## Urgent Field Safety Notice

### Single Chamber Temporary External Pacemaker 53401

June 2018

Medtronic reference: FA824

**FIGURE 1- updated firmware displayed in this image**

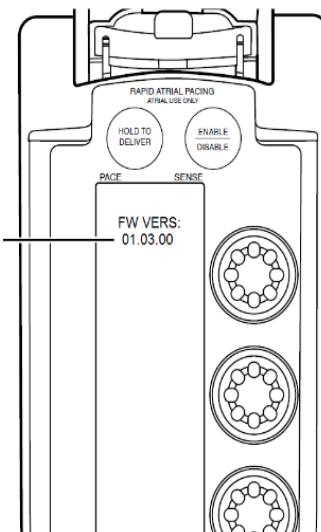
1. Verify whether 53401 EPGs in your possession are affected
2. If your EPG is affected, complete the following:
  - o Determine if the EPG firmware has been updated.
    - Power unit on and view firmware version (Figure 1 below).
    - If firmware version is 01.03.00 or greater, EPG firmware has been updated with correction for this issue. No other action is recommended.
    - If firmware version is 01.02.00, EPG firmware has not been updated. You may arrange to have your Medtronic Service Center update the EPG firmware at no charge.

During power up process, Firmware Version will be displayed for 2 seconds

Recently, Medtronic received approval for a firmware correction that prevents occurrence of this issue. Medtronic recommends customers send affected devices to Medtronic Service to update the firmware to prevent this issue.
